NISSAN RE4R01A / RE4F02A SOFT OR FLARED UPSHIFTS

Figure 1

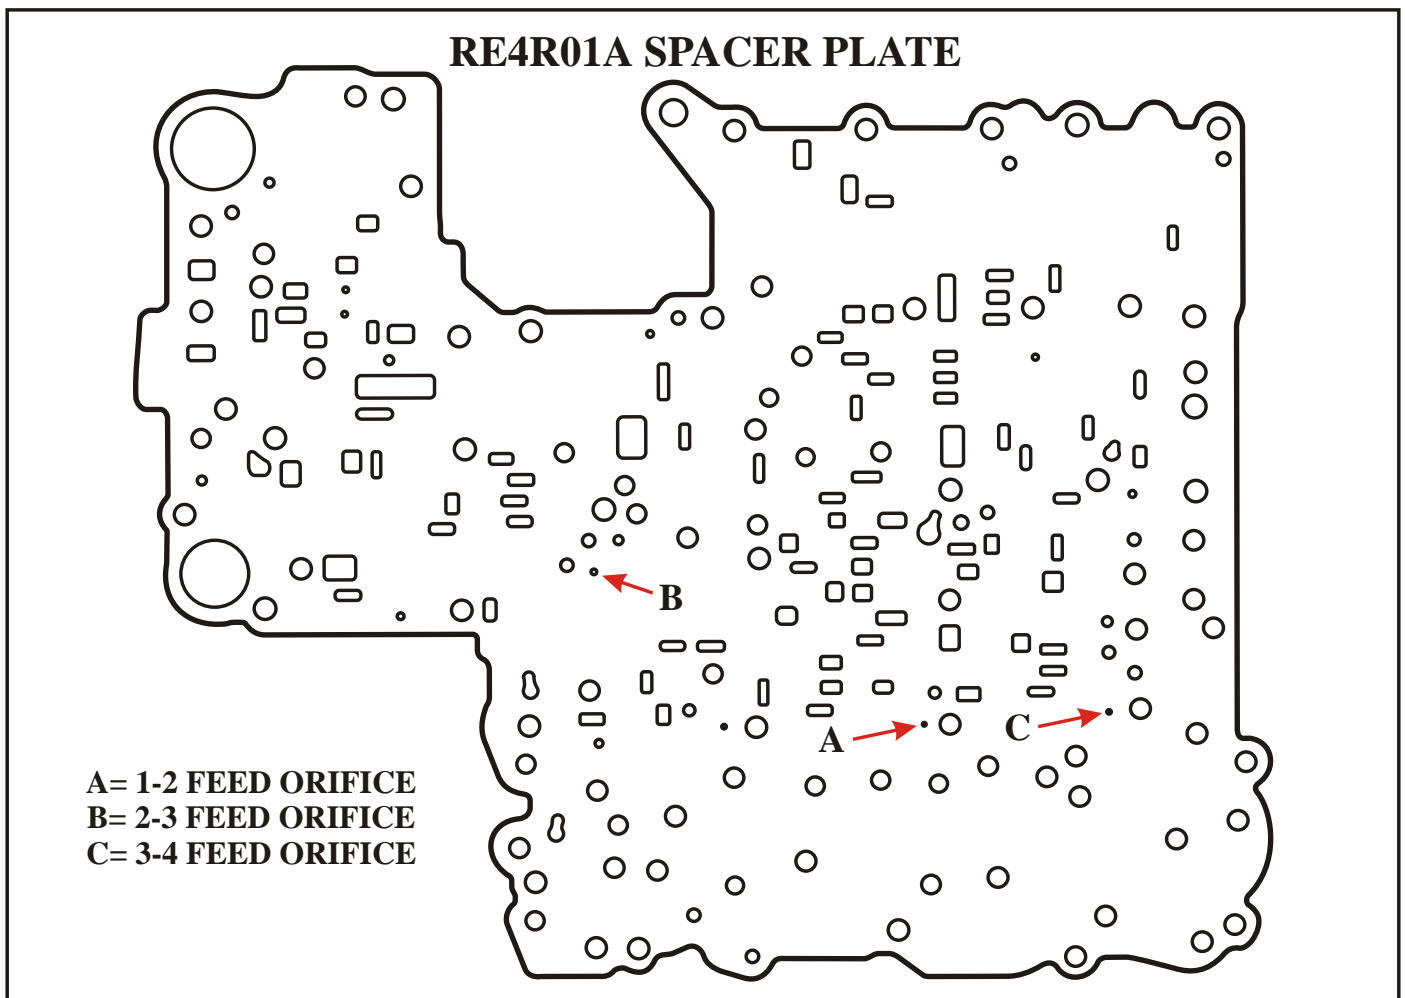
COMPLAINT: After overhaul, vehicles equipped with RE4R01A or RE4F02A transmissions, may exhibit soft or flared upshifts.

CAUSE: The cause may be, insufficient feed oil to the clutch or band servo related to the upshift taking place.

CORRECTION: Refer to Figure 1 for RE4R01A feed orifice locations. Refer to Figure 2 for RE4F02A feed orifice locations. To firm the upshift in question, enlarge the orifice marked in the spacer plate .020“--.030” larger.
